# SCHWEIZER SERVICE NOTICE

NOTICE NO. N-215  
DATE: SEPT 21, 1988  
PAGE: 1 of 5 pages

SUBJECT: Update of Model 269B and 269C Pilot's Flight Manual; Installation of 269A9928-5 and 269A9928-7 Center Cover Support Bracket.

MODELS AFFECTED: All Model 269B and 269C Helicopters.

FIGURE 1. CENTER COVER SUPPORT BRACKET

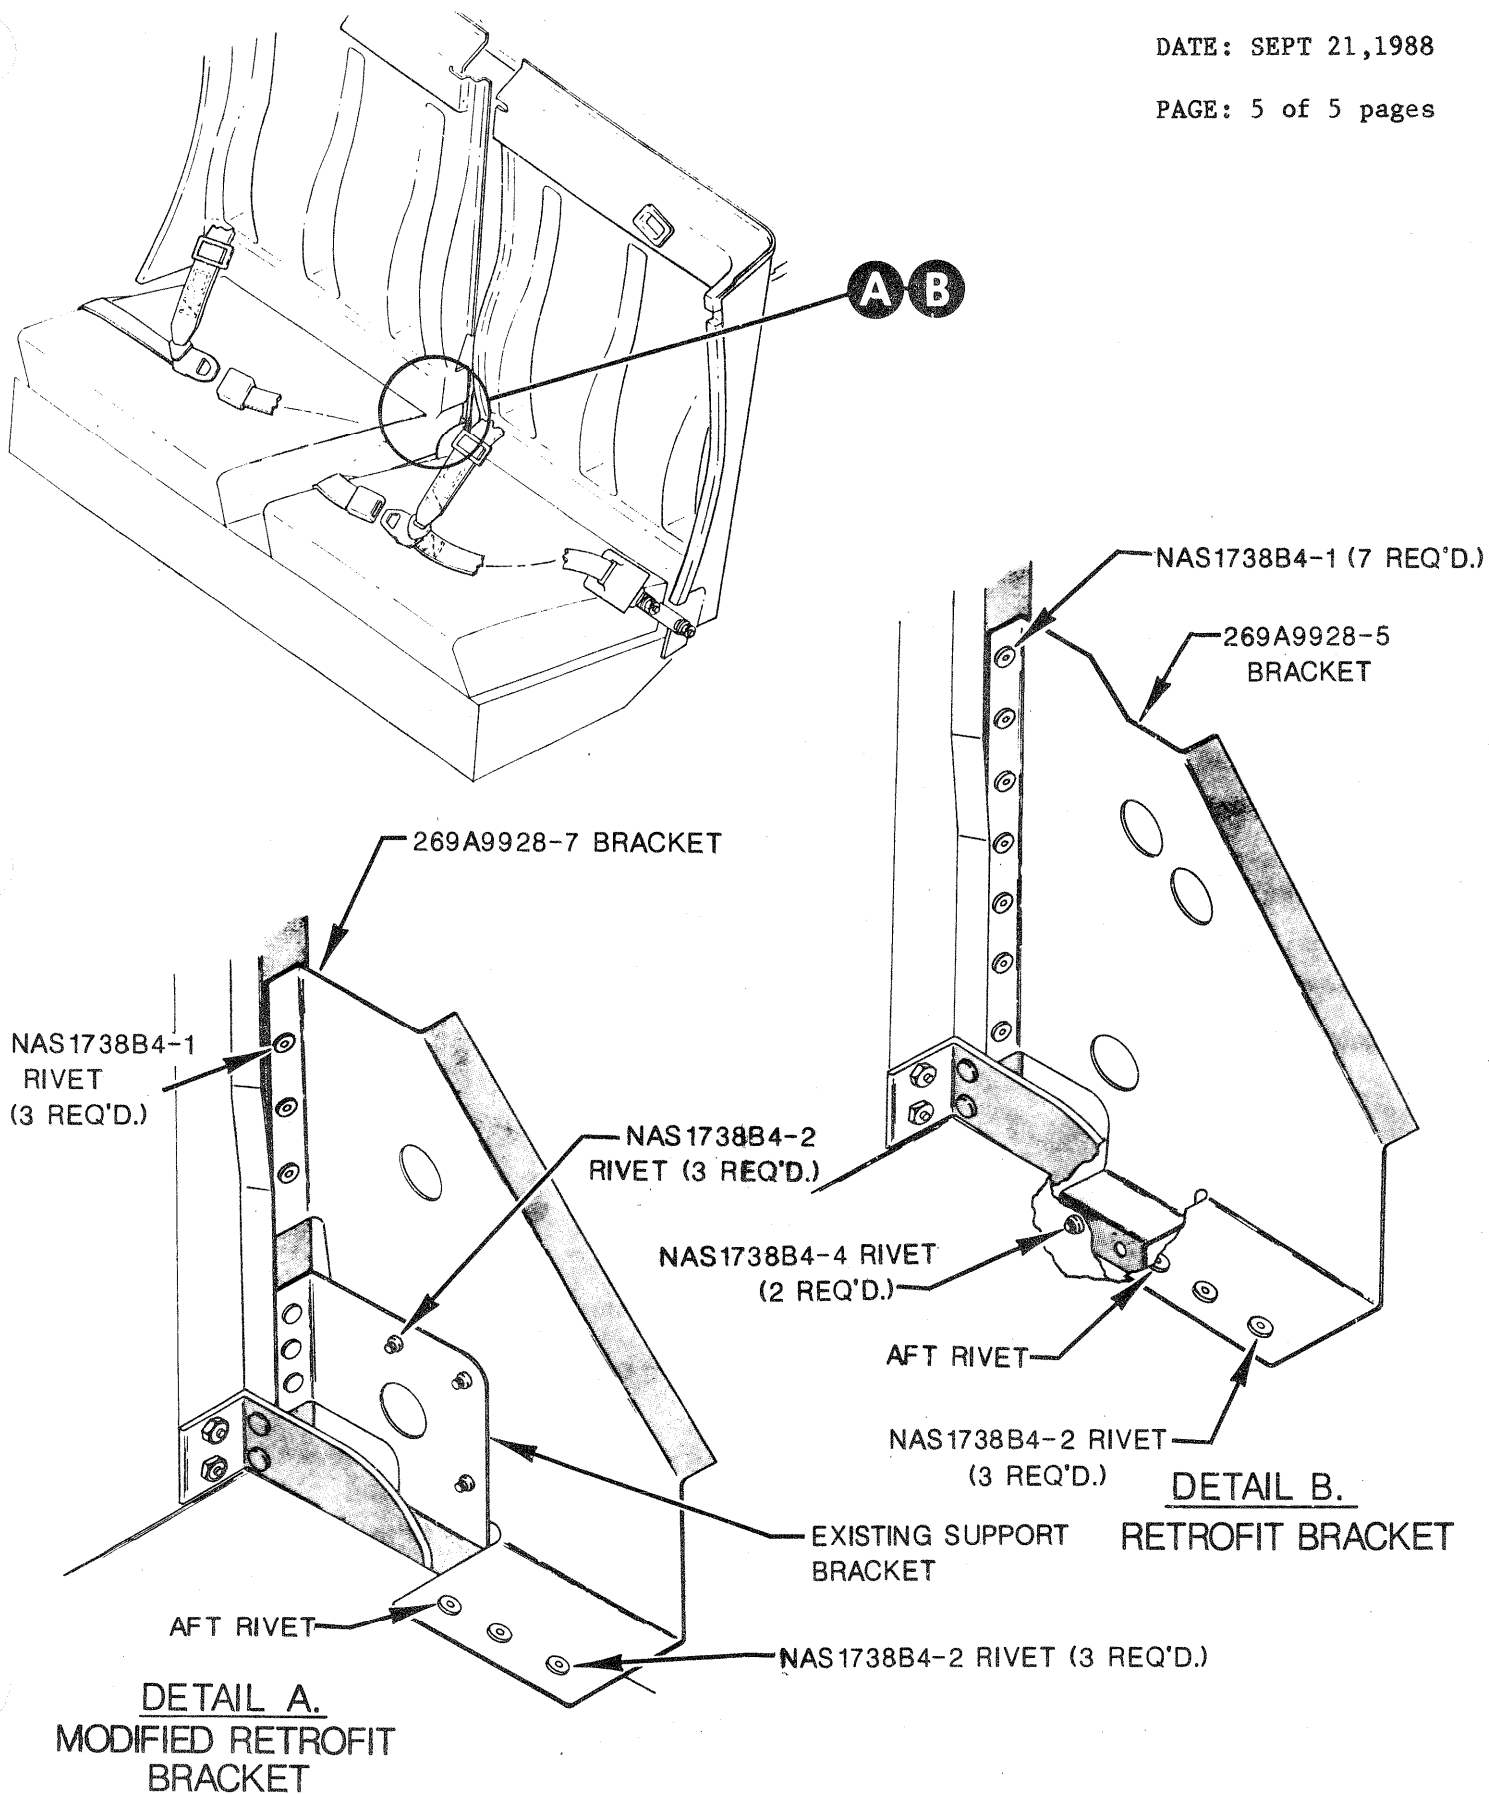
Part II of this Service Information Notice provides instructions for the installation of a larger center cover support bracket. This larger bracket has been designed to provide addition support between the center cover molding and the throttle linkage. The flanged portion of the bracket helps to ensure proper installation of the center cover molding. This larger bracket is currently being installed on model 269C Production Helicopters and SAC highly

- o The following procedure provides instructions to install either support bracket (269A9928-5 and 269A9928-7). Refer to Figure 1, Detail A when installing 269A9928-7 bracket (Modified Retrofit Kit) or Figure 1, Detail B when installing 269A9928-5 bracket (Retrofit Kit)
- o The existing support bracket does not need to be removed in order to install the improved support bracket on Model 269C Helicopters with Serial Numbers of 1150 through 1299. As shown in Figure 1, Detail A, the retrofit bracket fastens to the existing support bracket.

- (1) Remove AFT RIVET from seat bottom. (Refer to Figure 1 for location of AFT RIVET.)
- (2) Hold bracket in position between seat back and seat bottom as shown in Figure 1.
- (3) Transfer AFT RIVET hole location from seat bottom to mounting flange of support bracket.

Use pilot holes in bracket to locate rivet holes. Use a #31 drill bit to drill holes.

- (4) Hold bracket firmly in position and drill a hole through bracket upper mounting surface and seat back. Secure bracket to seat back with cleco fastener.
- (5) Drill hole through bracket forward mounting flange and through seat bottom; secure bracket to seat bottom with cleco fastener.
- (6) Ensure that bracket is in proper position before continuing with the installation.
- (7) Drill remaining holes and secure bracket to seat structure with appropriate rivets at locations shown in Figure 1, Detail A (Retrofit Kit) or Detail B (Modified Retrofit kit), as applicable.
